Staff Report & Recommendation

Historic Preservation Board

SUBJECT: HPB23-0575, **100 Block of Lincoln Road Right-of-Way and 1 Lincoln Road.**

An application has been filed requesting a Certificate of Appropriateness for improvements to Lincoln Road between Collins Avenue and the Beachwalk.

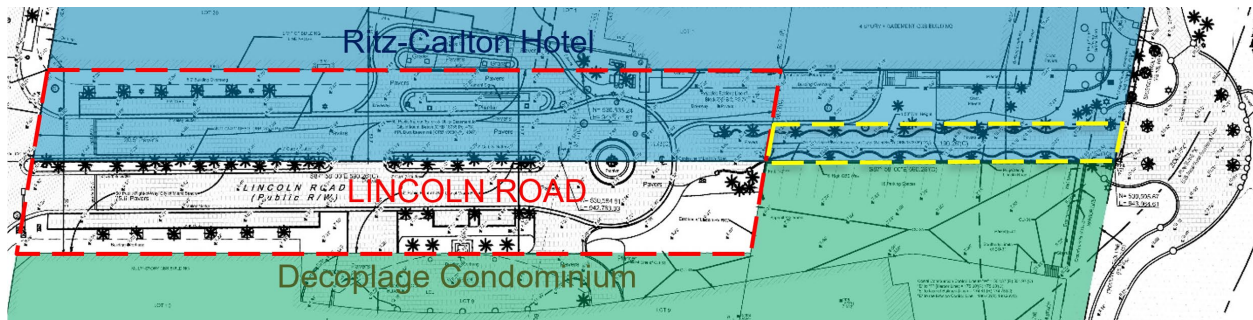
Staff would preface this analysis by noting the unique ownership conditions of the portion of Lincoln Road east of Collins Avenue. As can be seen in the diagram below, the northern half of what is recognized as Lincoln Road (red) is actually part of the Ritz-Carlton Hotel property (blue). Additionally, the northeastern corner of the Decoplage Condominium (green) property extends north to meet the Ritz-Carlton property. In order to provide access to the Beachwalk, the City has a 20'-0" wide pedestrian access agreement (yellow) within the southwestern corner of the property.

The subject application is limited to improvements to Lincoln Road (including the portion owned by the Ritz-Carlton and the pedestrian easement area (the areas outlined in red and yellow). Improvements include the reconfiguration of the roadway and sidewalks, the introduction of decorative paving and enhanced landscaping. Additionally, the applicant is proposing to modify the Ritz-Carlton Hotel drop off area including the widening of the pedestrian walkway along this portion of the building and the introduction of a new driveway and loading area configuration. Staff would note that as part of a separate application (HPB23-0574), the application is also proposing the introduction of a new porte-cochere to provide protection for the proposed drop off area.
